**ADDENDUM NUMBER: #1**

**Date: February 24, 2025**

Project Name: Rio Grande City- Starr County Juvenile  
Detention Center Upgrades

Milnet Project No.: 224028

A7.0

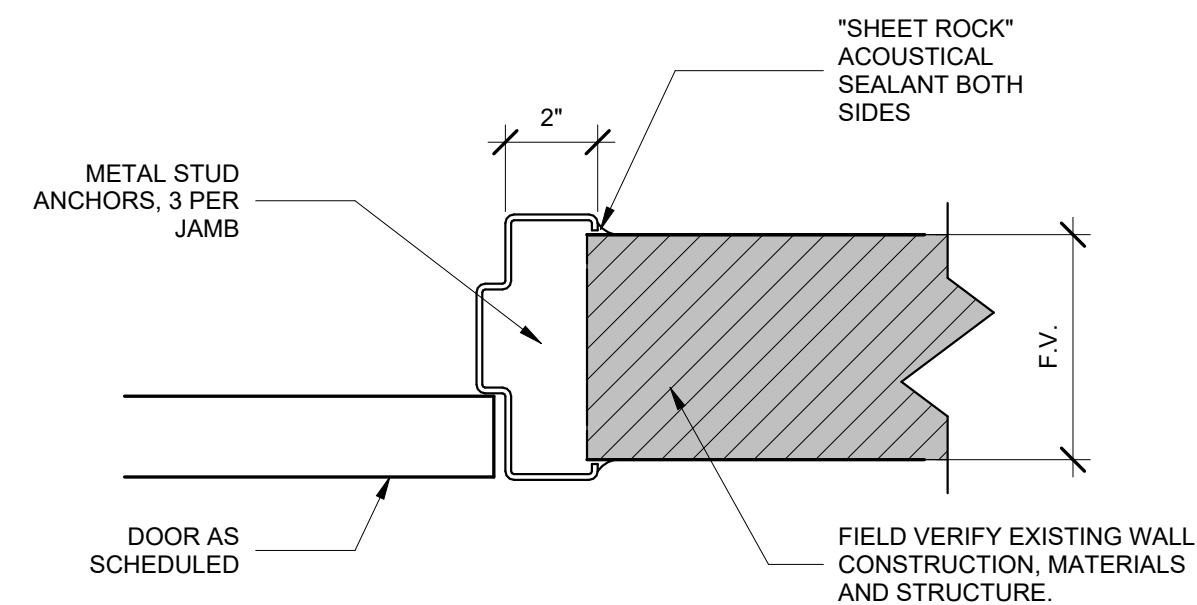
- 1.05 What is the proposed budget for the project?  
**Response: This information will not be disclosed at this time.**
- 1.06 Are we adding a new sink to the dayroom?  
**Response: No, all existing sinks are to remain.**
- 1.07 Do we replace locks on shower doors?  
**Response: No.**
- 1.08 Add intercoms at all cells?  
**Response: Yes.**
- 1.09 Card access locations?  
**Response: Refer to the updated door schedule on the attached revised sheets.**
- 1.10 Added structural sheets
- 1.11 CORRECTION: Sheet D1.0- DEMO FLOOR PLAN
- Updated note callout on doors
  - Added note to existing millwork and sink
- 1.12 CORRECTION: Sheet A1.0- FLOOR PLAN
- Updated floor plan to show relocation of washer from dayroom to storage
  - Added door B036 to scope of work
- 1.13 CORRECTION: Sheet A7.0- SCHEDULES
- Updated door schedule
- 1.14 Added sketch: AS1.0- SK1
